Bedroom Wall B — Revision B

Tisa chose Option 3 on 2 Nov 2026: three equal tall bays, upper and lower frames, on Wall B. This revision replaces every Wall B instruction in the 12 October packet. Wall A, heights, profile, colours and outlets do not change.

1 Wall B — measured elevation

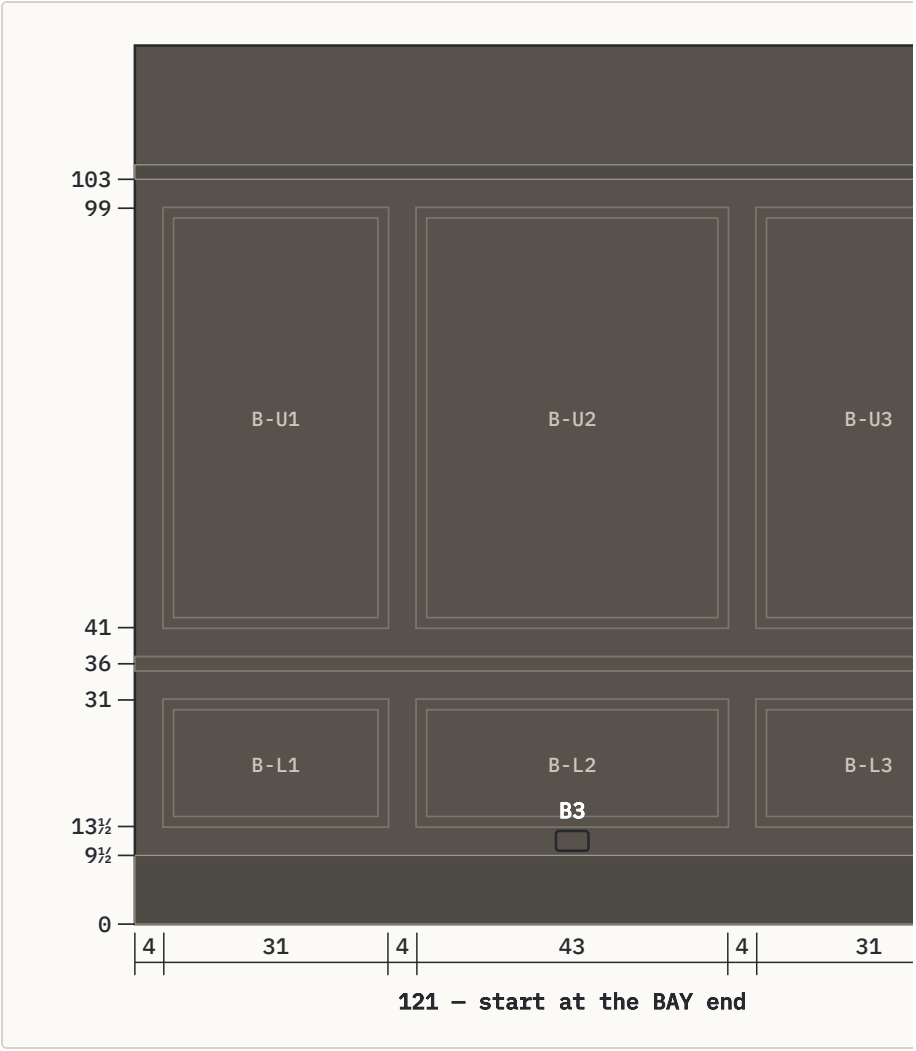
- Three lower frames are now 31 / 43 / 31 wide (were 35 / 35 / 35).
- Three new upper frames, 31 / 43 / 31 wide × 58 high, floor 41–99. The upper wall is no longer plain.
- Moulding order rises from 14 to 21 eight-foot boards; adhesive from 5 to 7 tubes; caulk from 2 to 3.
- Replaces packet pages 2–3 (Wall B lines), 6, 7 (O-A to O-C), 8–9 (quantities), 10 step 4, 11, 17, 20, 23 (Wall B) and 27.

Check: 4 + 31 + 4 + 43 + 4 + 31 + 4 = 121. Composition centre 60½. Upper frames start 4 in above the chair-rail top (37 → 41); lower frames end 4 in below its bottom (31 → 35).

FRAME	LEFT → RIGHT	BOTTOM → TOP	OUTSIDE W × H	OPENING (1¼ FACE)
B-U1	4" → 35"	41" → 99"	31" × 58"	28½" × 55½"
B-U2	39" → 82"	41" → 99"	43" × 58"	40½" × 55½"
B-U3	86" → 117"	41" → 99"	31" × 58"	28½" × 55½"
B-L1	4" → 35"	13½" → 31"	31" × 17½"	28½" × 15"
B-L2	39" → 82"	13½" → 31"	43" × 17½"	40½" × 15"
B-L3	86" → 117"	13½" → 31"	31" × 17½"	28½" × 15"
